Review of the Union Electric Company Integrated Resource Plan

The Office of the Public Counsel

Technical Report

Case No. EO-2011-0271

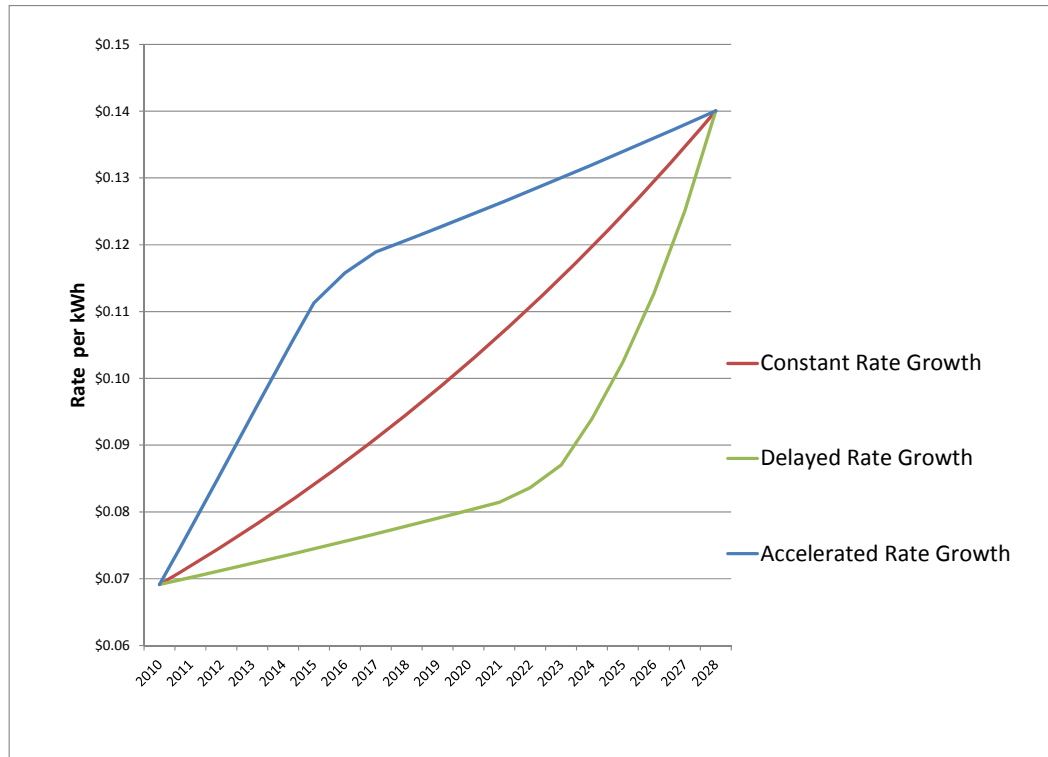
The customer satisfaction metric has two clear problems. Firstly, it awards the Constant Growth scenario a score twice as strong as the Delayed Growth scenario, despite the total ratepayer cost of the Delayed Growth scenario being 14% lower. Secondly, it awards the Delayed Growth and the Accelerated Growth scenarios equal scores, despite the Delayed Growth scenario costing 25% less than the Accelerated growth scenario. A well-tuned customer satisfaction metric shouldn't score moderately priced plans significantly better than inexpensive plans, nor should it score a costly plan equal to an inexpensive plan.

Secondly, the model doesn't weigh the rates by the probability of each scenario¹⁷, creating a bias in the rate results. Recall that there are ten scenarios with varying probabilities, ranging from four different "Energy Bill" Mandates each with 14.25% probability to the Business As Usual case with probability 0.5%. Instead of weighing the rates required by each scenario by that scenario's probability, the Company's model simply sums the rates and divides by 10, as if each scenario were equally likely. This modeling error results in future electricity rates related to the BAU scenario (a 1/200 chance) being substantially overweighed, whereas results from more likely scenarios such as Federal Energy Policy being substantially underweighed. This error is rectified in the corrected model Synapse produced and applied to the final set of candidate resource plans.

Finally, in direct contradiction to CSR 240-22.060 (2), the customer satisfaction calculation in the model uses a simple mean average rate rather than a levelized annual average rate.

The Relative Benefits of the Energy Efficiency Scenarios

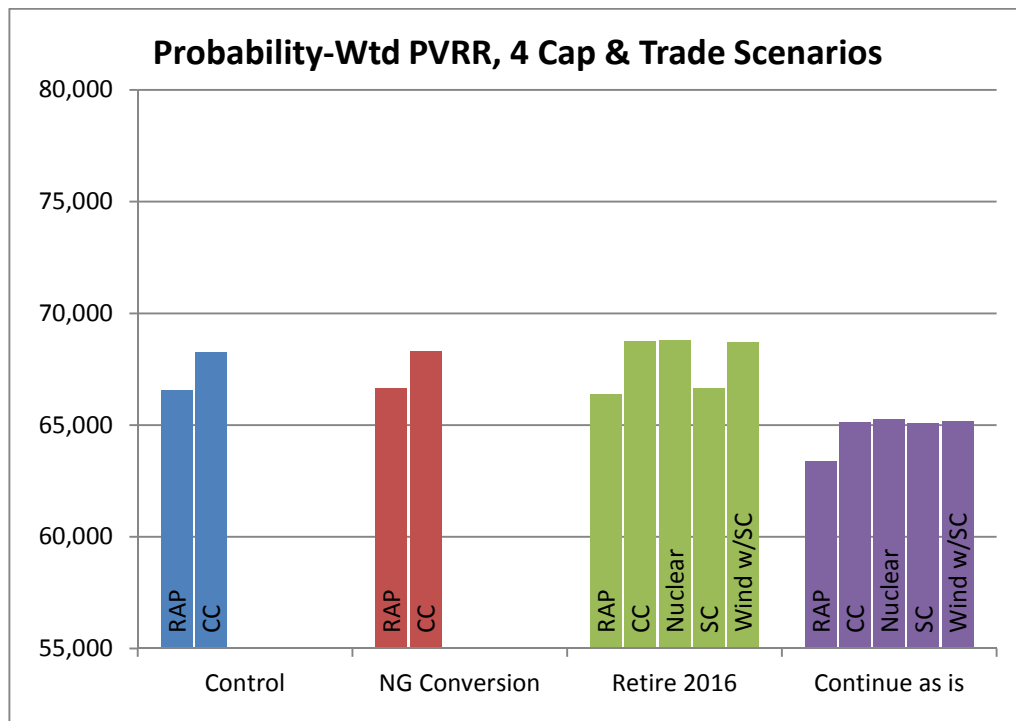
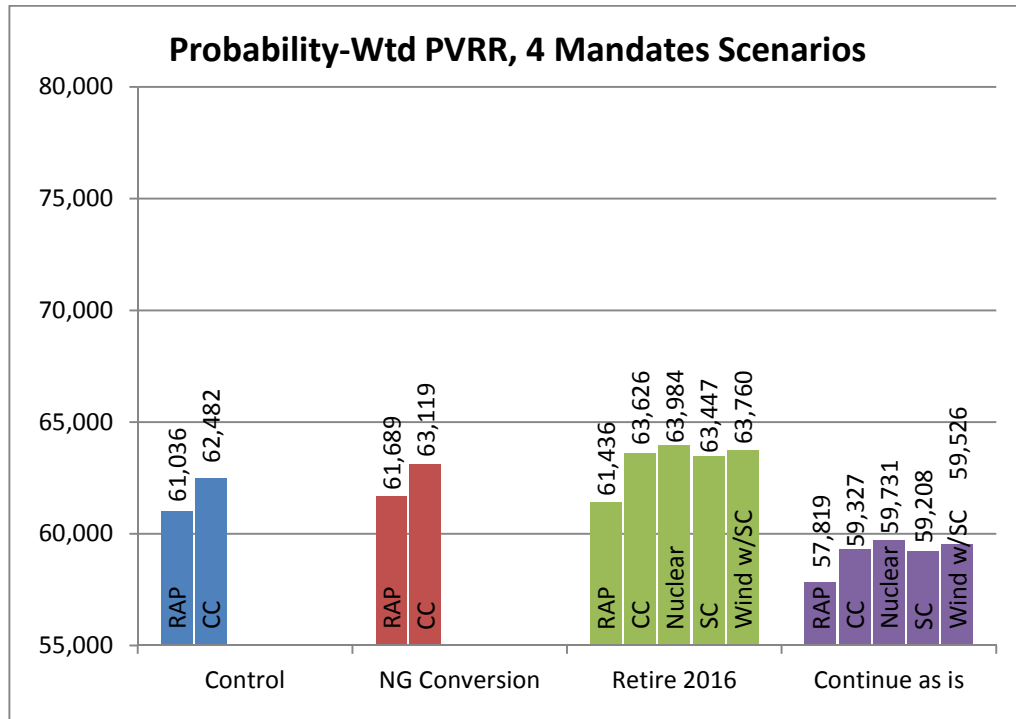
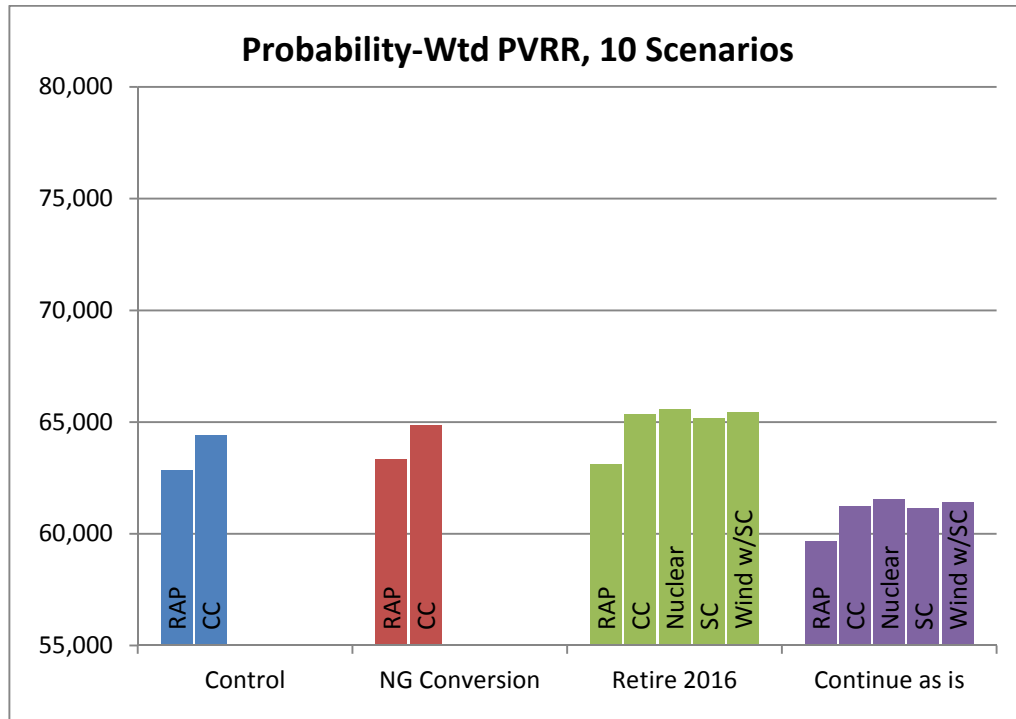
One of the most striking results of the risk analysis at this point is the finding that the plans containing the RAP level of energy efficiency clearly result in the lowest PVRR under all scenarios and sensitivities. First, UE conducts some comparisons of the RAP scenario with the Capacity Calibrated Portfolio (CCP) scenario, which combines energy efficiency and demand response at just enough amounts to defer future capacity additions. The CCP scenario includes less energy savings than the RAP scenario but greater amounts of demand response than is included in some plans with the RAP level of energy efficiency. Under all sensitivities run by the Company (including Meramec controlled, Meramec converted and Meramec retired in 2016), the RAP plans result in lower PVRR than the CCP plans.²⁰ Based on these findings, the Company decides that further analysis of plans with CCP is unnecessary.²¹

Second, UE conducts several risk analysis sensitivities of the 14 candidate resource plans. Every sensitivity conducted demonstrates that the RAP efficiency plans result in the lowest PVRR. In the cap-and-trade scenarios, RAP has lower cost than combined cycle (CC), nuclear, simple cycle (SC), and wind, whether Meramec is controlled, converted to natural gas, retired in 2016, or allowed to continue as-is. Under the environmental mandate scenarios, the same is true: RAP performs best. When all ten scenarios are probability weighted, RAP again turns out to be cheapest.

This point is demonstrated in the charts below. These charts were derived by simply rearranging the data presented in Figures 9.16, 9.17, and 9.18 in Chapter 9. The PVRR results for the RAP plans were placed directly next to the PVRR results for comparable Meramec scenarios, to provide an indication of how much money the RAP plan can save relative other plans in a directly comparable scenario. As indicated in the charts, the RAP plans result in the lowest PVRR under all of the risk analyses.
